Revised Pages For Topical Report DPC-NE-2005P

TOPIC REPORT DPC-NE-2005 - THERMAL/HYDRAULIC STATISTICAL CORE DESIGN METHODOLOGY
C. Harwood contacted Duke Power - 8/3 TELCON with S. Gewehr, Duke Power. "None of these pages, specifically pages 28 and 30 are proprietary"

FIGURE 2

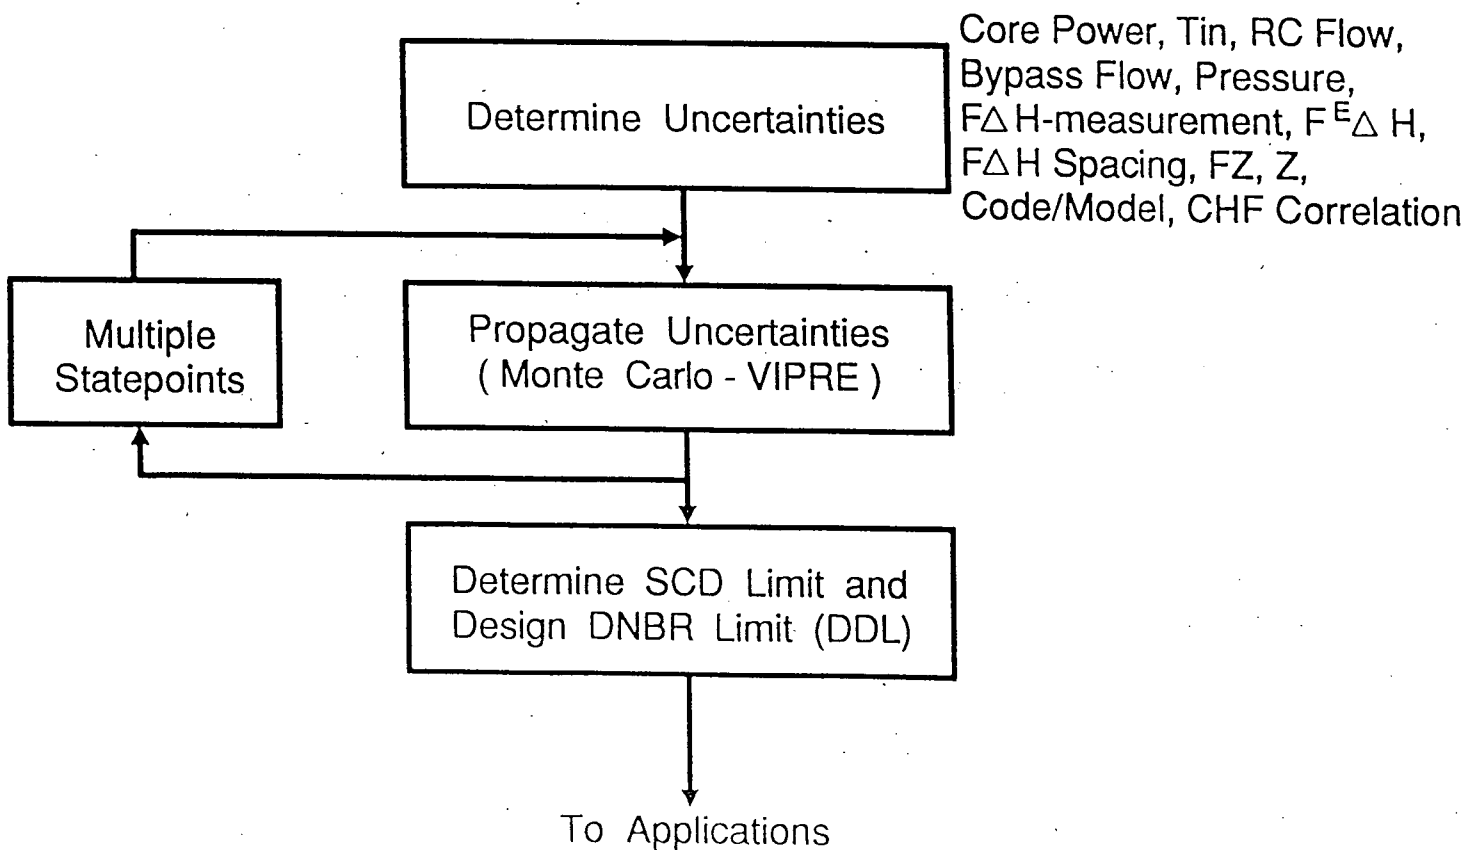
REVISED SCD FLOWCHART
